GROSS RESERVOIR HYDROELECTRIC PROJECT

PROJECT NO: 2035-099

DENVER WATER, LICENSEE

**Submitted via eFiling by Michael Thomason, President
The Environmental Group**

Figure 2: Storage (AF) in Additional 72,000 AF Volume of Expanded Gross Reservoir: Using Additional Divertible Water from Upper Basins

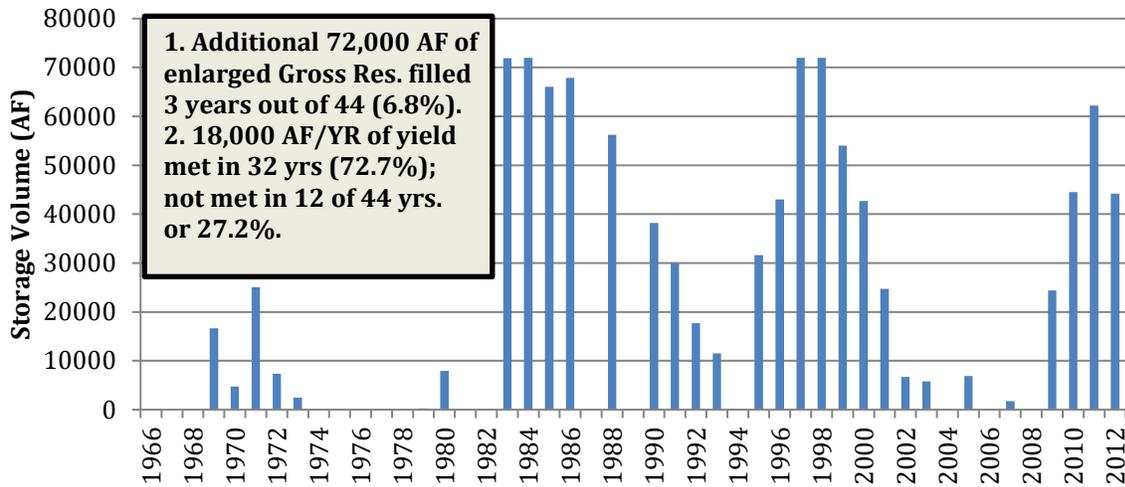
If Denver Water uses up to 18,000 additional acre-feet in years when additional water is available, then based on estimates of additional divertible flows determined in the firm yield analysis, **the expanded portion of the reservoir would fill in only 3 years, would be almost full in 1 year, would be less than half full in 30 years and would be at or near empty in 16 of the 44-year test period** (Figure 2). Streamflow in the late 1980s and early 1990s depleted the expanded storage to zero by 1994. The enlarged reservoir storage was also depleted for several years in the 1970s and 2000s.

If Denver Water uses up to 18,000 additional acre-feet in years when additional water is available, based on a full-use (meaning the supply is fully used, predicted for 2022) project baseline, the expanded portion of the reservoir would fill in only 1 year (2.3%), be less than half full in 31 years (70%), and at or near empty in 24 years (54%) of the 44-year test period (Figure 3).

Figure 5: Excess Yearly Flow in Fraser and Williams Fork Basins Estimated Using USGS Flows and Gross Reservoir Storage Data in May, June, and July: 1966 to 2012

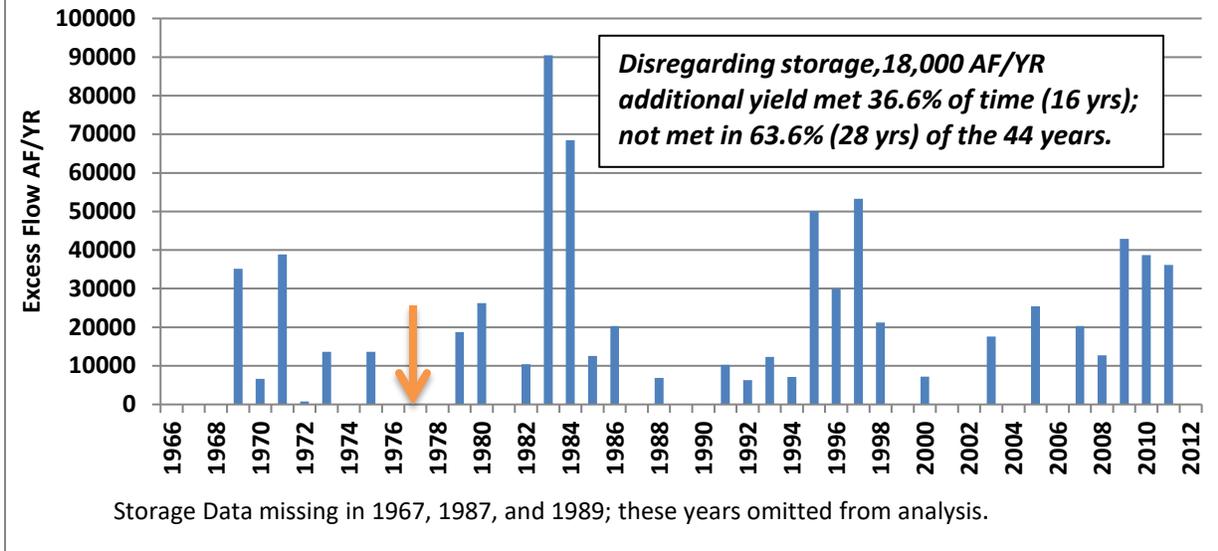
Adjusted monthly stream flows in May, June, and July were summed to estimate the yearly total excess basin flow that would be available to fill the expanded Gross Reservoir storage of 72,000 AF. Estimated yearly excess flows are shown in Figure 5.

Average and median excess flows at each USGS gage location are shown in Table 3. Average estimated excess flows compare favorably to average tunnel diversion increases from “current” to “proposed” conditions modeled in the FEIS using the PACSM model (Table 4). In fact, the average of the estimated excess flows in both the Fraser and Williams Fork basins combined actually exceeds the modeled increase in Moffat flows by approximately 2,600 AF/YR on average and so represents a “best case” estimate of the ability of the proposed project to meet the firm yield requirement of 18,000 AFY. Average excess flows calculated for the Fraser Basin alone compare closely to the modeled increase in the Moffat Tunnel diversions.

Figure 6: Storage (AF) in Additional 72,000 AF Volume of Enlarged Gross Reservoir NOT Accounting for Full Use

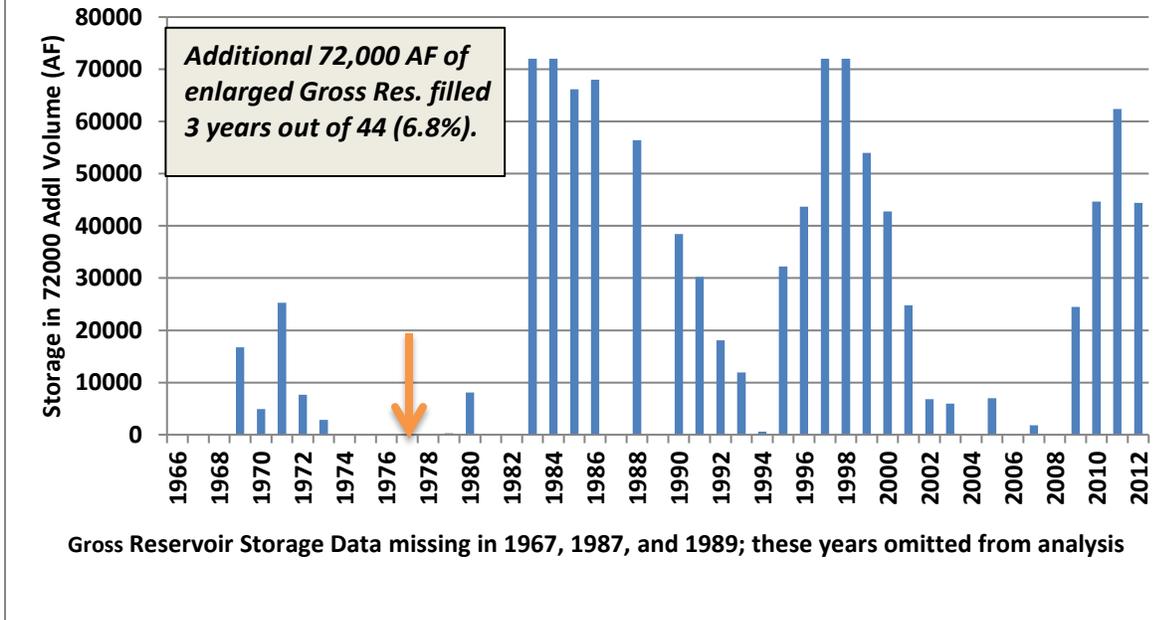
Estimated storage in the 72,000 AF of the expanded Gross Reservoir for 44 years between 1966 and 2012 (omitting 1967, 1987, and 1989) is shown in Figure 6. Storage levels and the ability to meet the firm yield requirement of 18,000 AF/YR in the expanded reservoir depend on hydrologic conditions in the first few years of filling, periods of drought (mid-1970s and mid 2000s), and periods of high flow (mid 1980s, late 1990s, and 2011). Based on this estimate of firm yield of the Fraser and Williams Fork Basins the expanded gross reservoir would fill in only 3 years and the 72000 AF of extra storage would be depleted or zero in 12 years (assuming all available yield under 18,000 AF would be used).

Year 1983 was notable. High snow pack and spring rains produced major flooding on the Colorado River. June and July issues of High Country News were awash in news of the flood: *“A record 120,000 cfs was flowing into Lake Powell from late spring snow and rain in the Rocky Mountains that no one had anticipated. On July 2, the lake - considered full at 3700’ - was just 3.5 feet from its maximum capacity of 3711’ and rising three inches a day.”*

Figure 9: Excess Yield from the Expanded Gross Reservoir Accounting for Full Use: Full Use Baseline

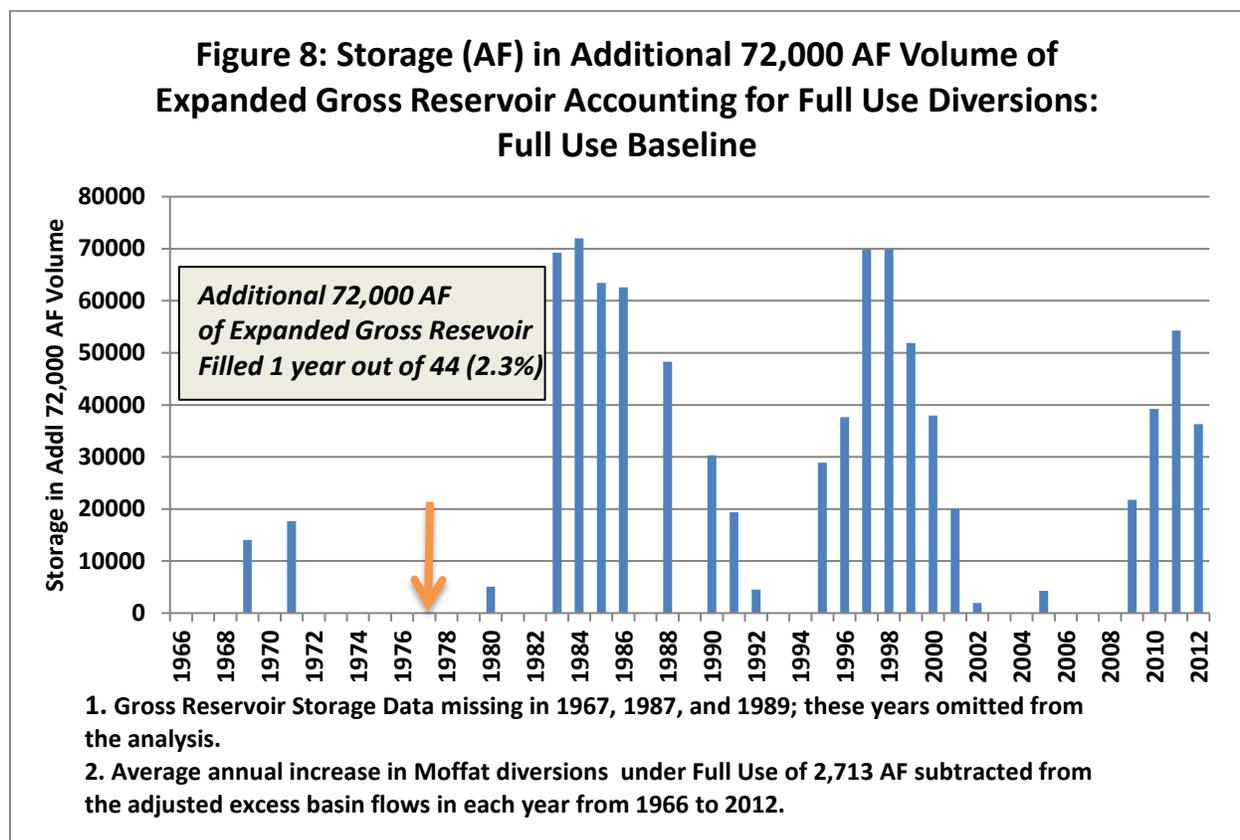
In particular, from 1972 through the end of the 1970s, excess storage in the expanded Gross Reservoir was zero with excess yield also low to zero during this time period (Figure 9). As before, 18,000 AF of additional yield was achieved in 2002 because of high flow years in the late 1990s. However, excess storage in the expanded Gross Reservoir was depleted by 2002 and very low or zero from 2002 to 2008. Perhaps the 1970s and mid-2000s should be included as other critical time periods by which to judge the feasibility of the proposed project.

Even with additional excess basin flows of 2,682 AF/Y overestimated in this calculation, the required yield of 18,000 AF/YR would be met in 24 years (54.5%) and not met in 20 years (45.5%) of this 44 year period of record. The percentage of years where the firm yield of 18,000 AF/YR was met was much less than 100% and so did not meet the PN1 FEIS screening criteria.

**Figure 3-1: Schematic of Four Baselines:
Two Historical and Two FEIS Baselines**

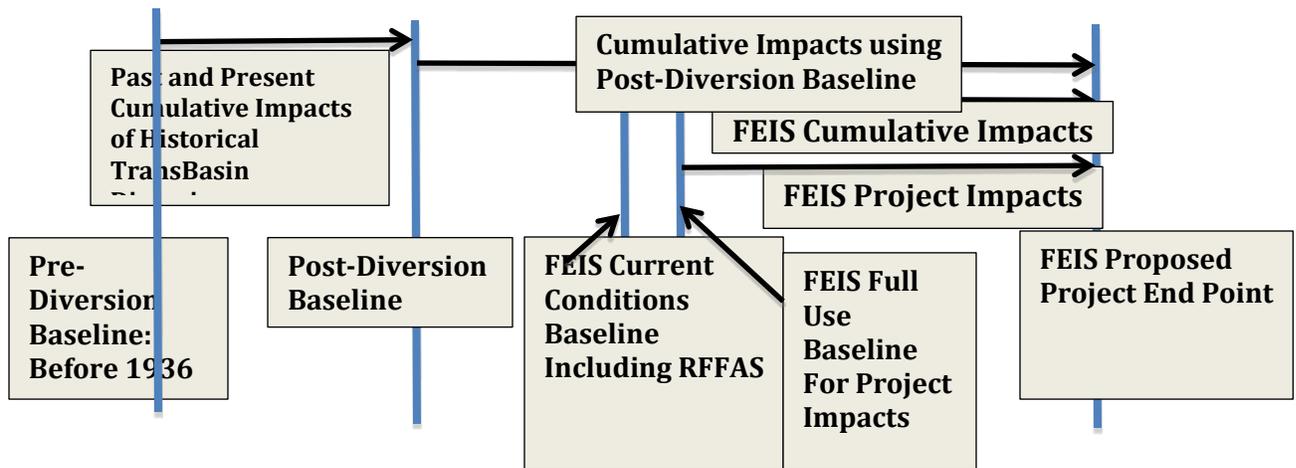
The following briefly discusses four baselines considered in this white paper and evidence that the FEIS Current Conditions baseline, derived using the PACSM model and used to evaluate FEIS cumulative impacts of the proposed project with RFFAs, does not reflect existing conditions in the western slope source basins and is not an appropriate baseline per NEPA. The historical post-diversion baseline which reflects existing conditions in the western slope basins is more appropriate and should be used for impact analysis in the FEIS. These baselines are shown in Figure 3-1.

Pre-Diversion Baseline: This is the historically measured pre-diversion record. On the Fraser River and the Colorado River downstream of the confluence with the Fraser, this baseline represents conditions before diversions through the Moffat Tunnel commenced in 1936. This is the most appropriate baseline by which to evaluate cumulative impacts of past and present diversions.

Post-Diversion Baseline (Existing Conditions): This baseline represents the actual existing conditions of the rivers. On the Fraser River, this baseline represents conditions after diversions through the Moffat Tunnel commenced in 1936, sometimes referred to as post-Moffat. On the Colorado River downstream of the confluence with the Fraser, this post-diversion baseline represents conditions after 1985; after all upstream historical transbasin diversions including the Moffat, Colorado Big Thompson, and Windy Gap projects were implemented.
